**Proposed DIY changes to
Cooker circuit previously altered by electrician**

Original cooker switch location

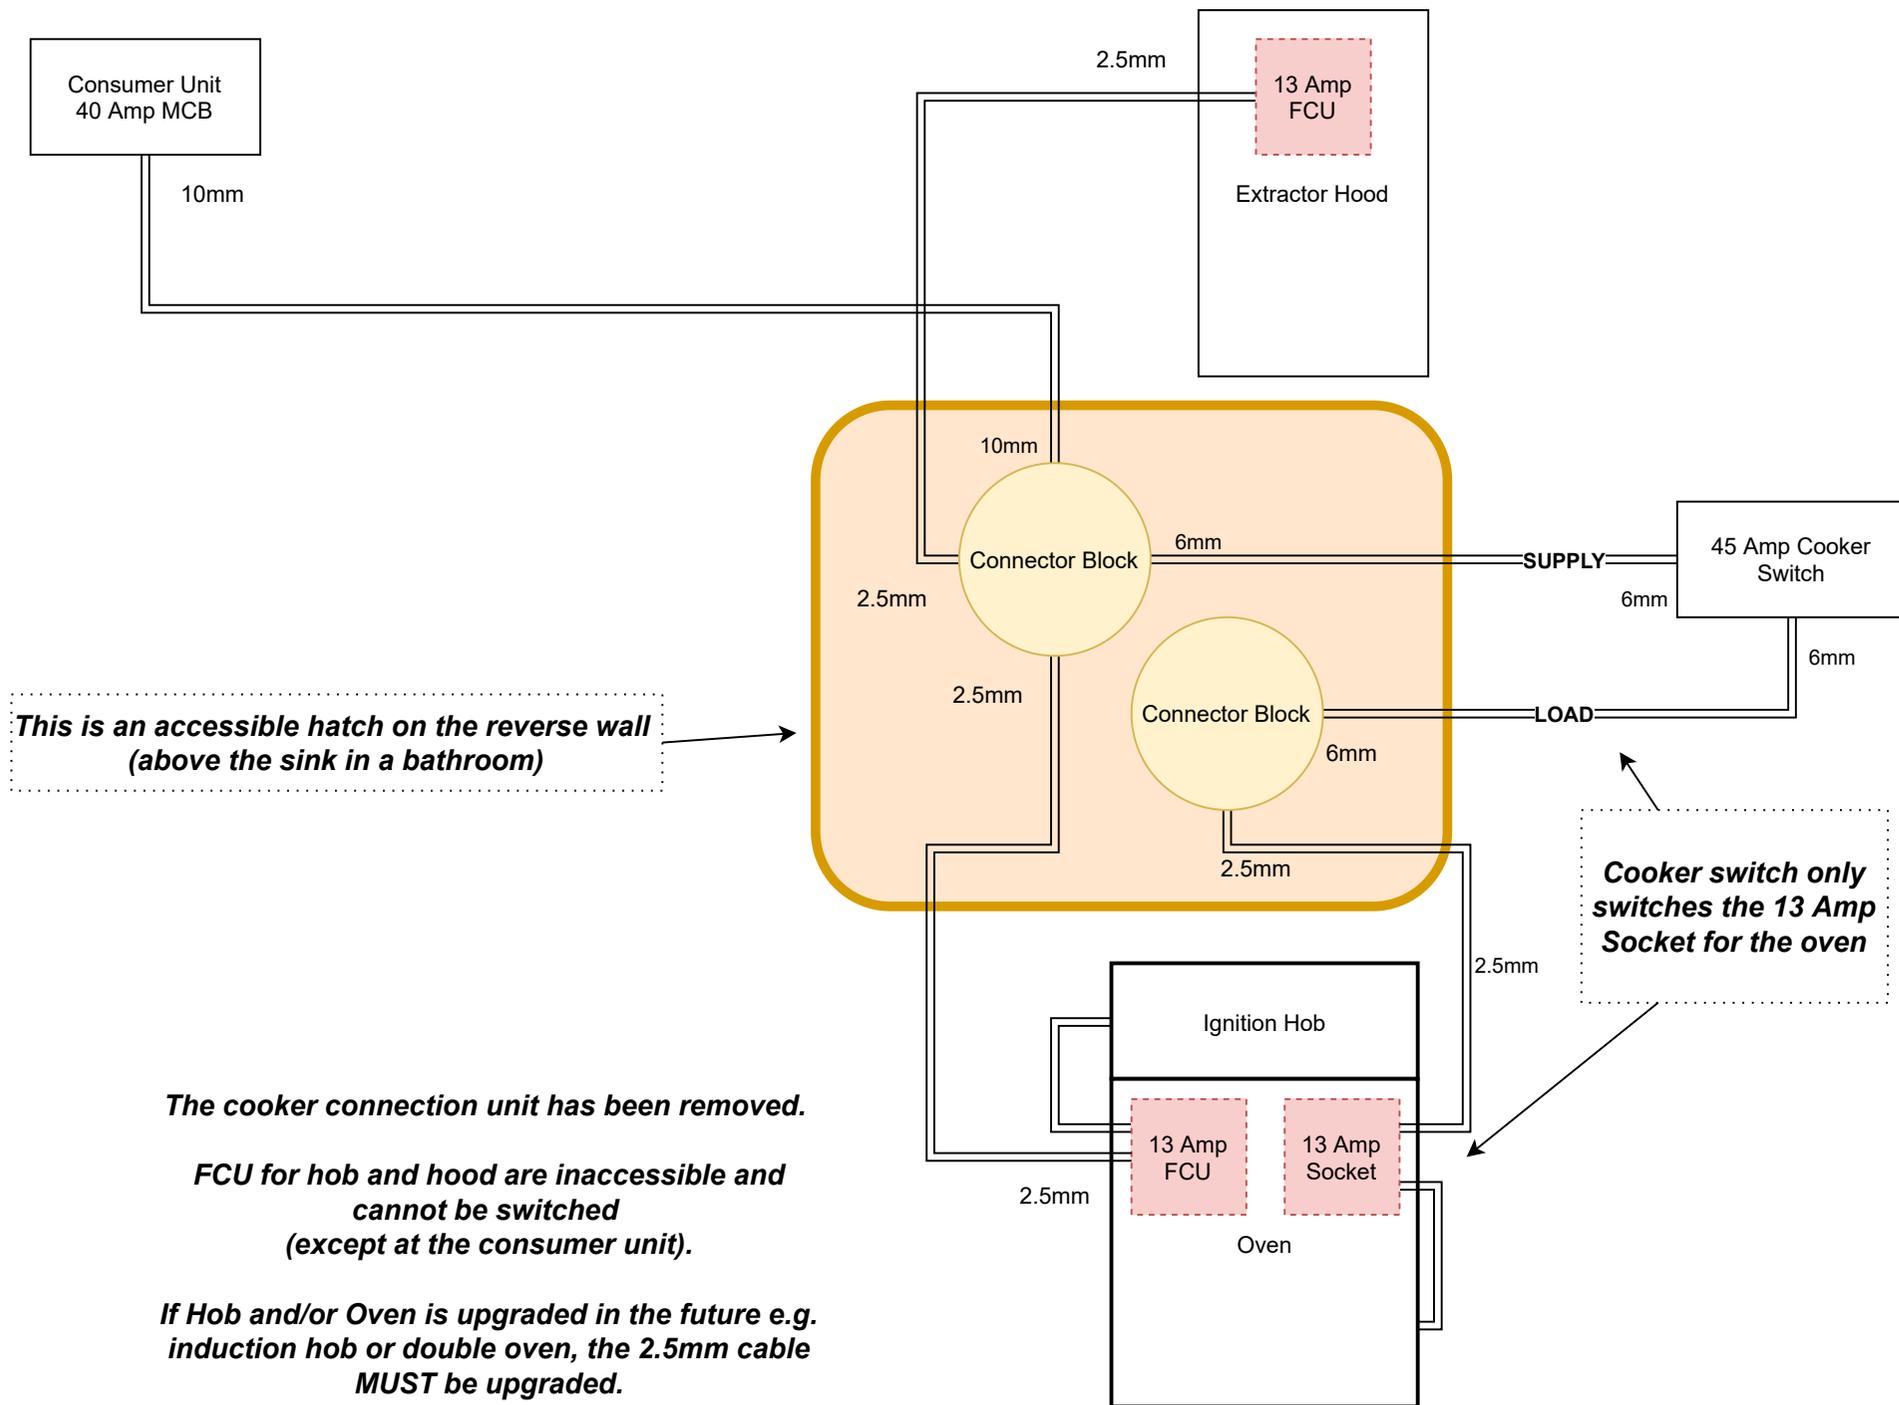
FCU for the Hood is inside its duct and is inaccessible unless the entire Hood is removed

The WAGO connectors were not in an enclosure and were inaccessible/plastered over inside the wall.

The Neutral conductor was not connected and the builder was unable to comment.

An electrician later broke the wall to find the connections and reconnected the Neutral.

6mm T+E and WAGO connectors was used to move the Cooker switch 300mm away from the hob

The cooker connection unit has been removed.

FCU for hob and hood are inaccessible and cannot be switched (except at the consumer unit).

If Hob and/or Oven is upgraded in the future e.g. induction hob or double oven, the 2.5mm cable MUST be upgraded.

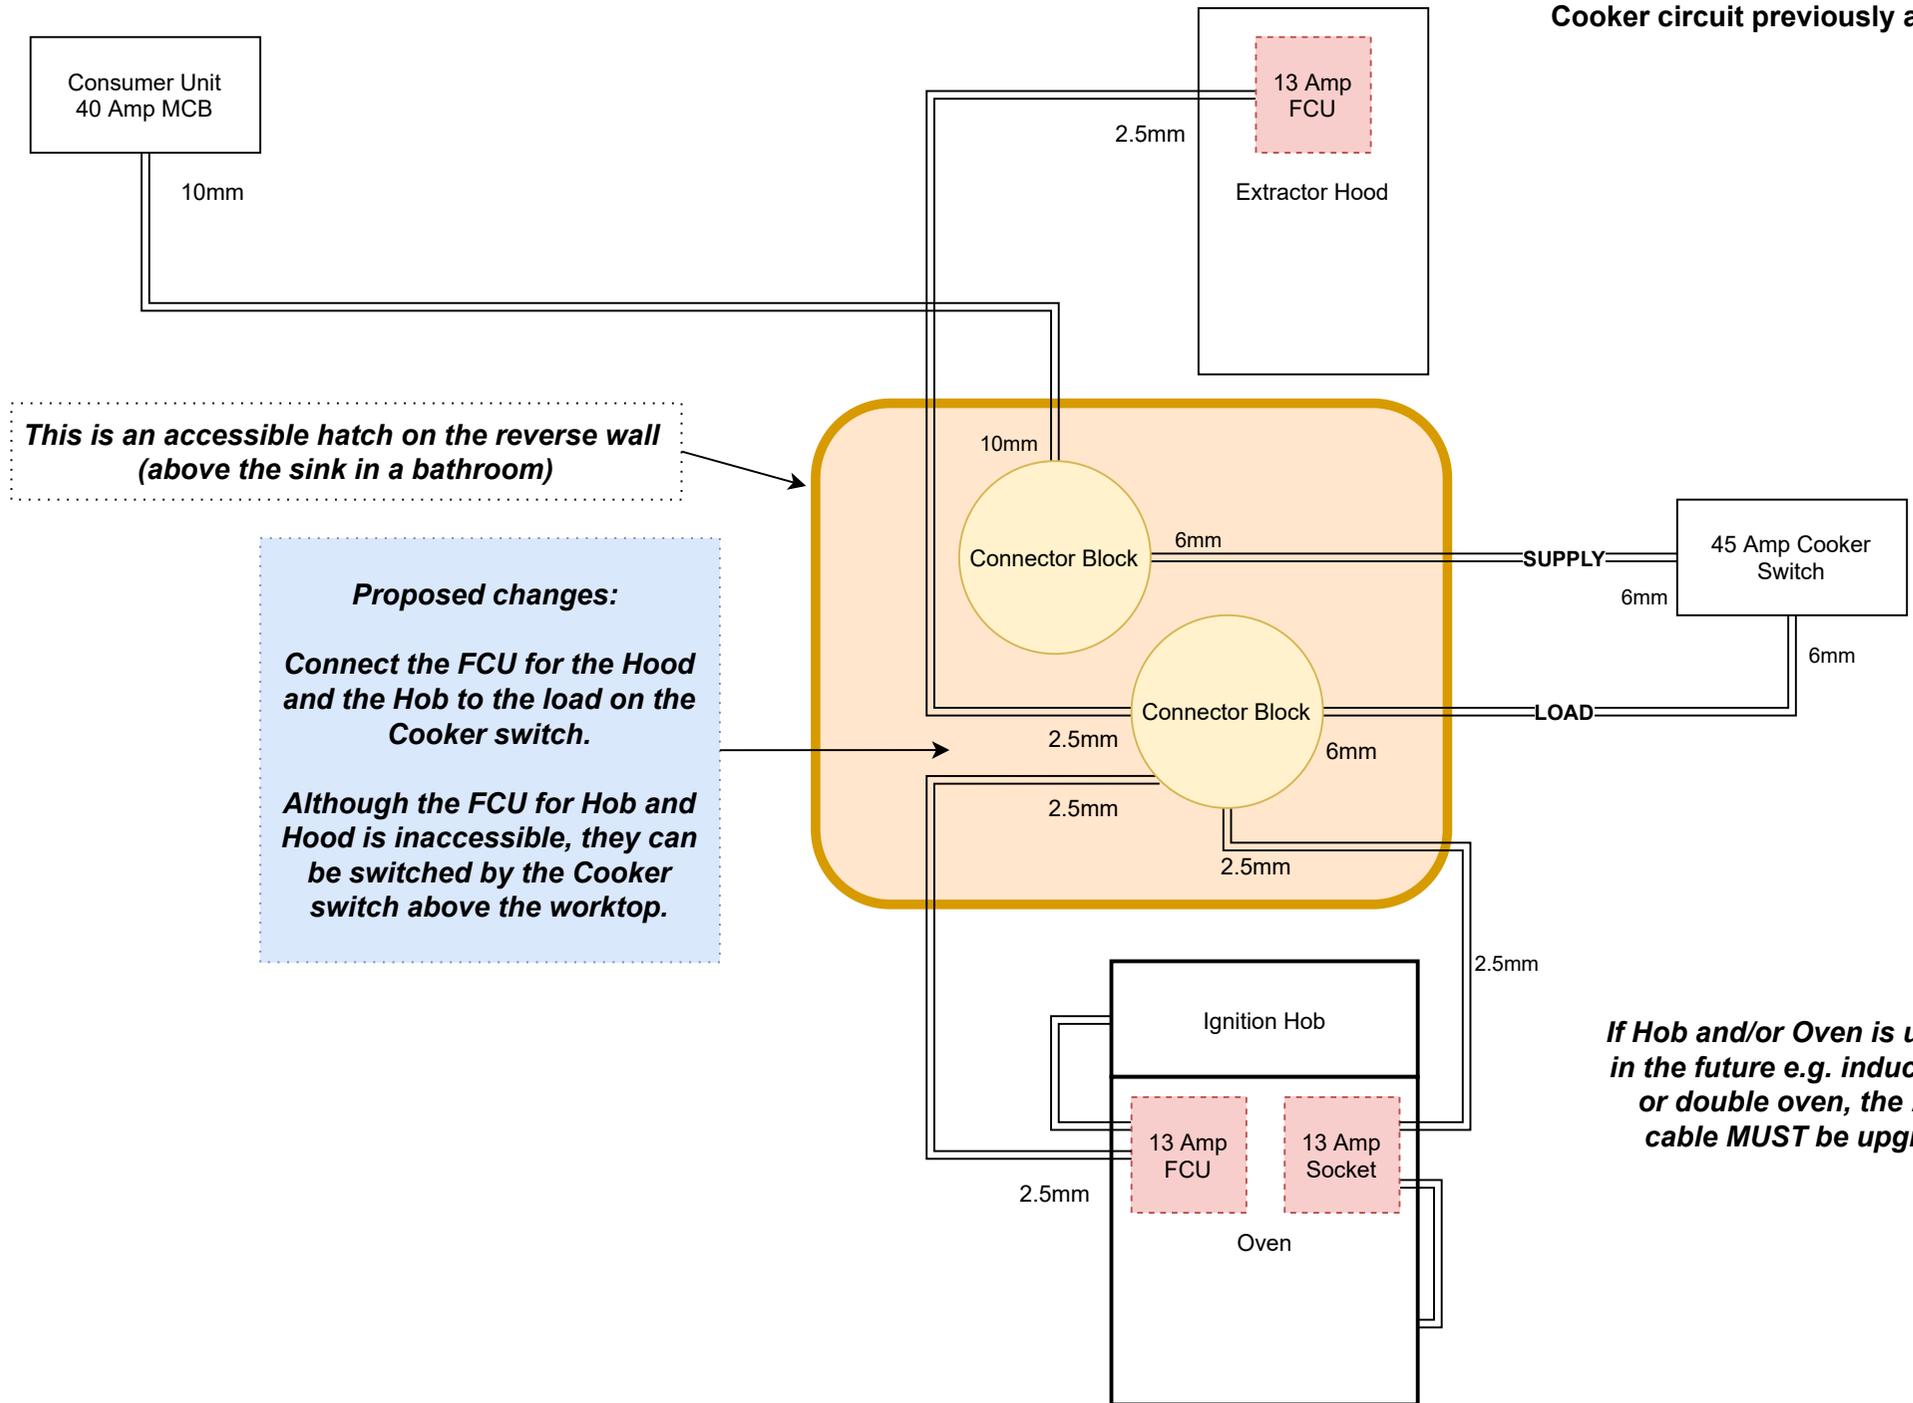
*This is an accessible hatch on the reverse wall
(above the sink in a bathroom)*

**If Hob and/or Oven is upgraded
in the future e.g. induction hob
or double oven, the 2.5mm
cable *MUST* be upgraded.**

Proposed changes:
**Connect the FCU for the Hood
and the Hob to the load on the
Cooker switch.**
**Although the FCU for Hob and
Hood is inaccessible, they can
be switched by the Cooker
switch above the worktop.**
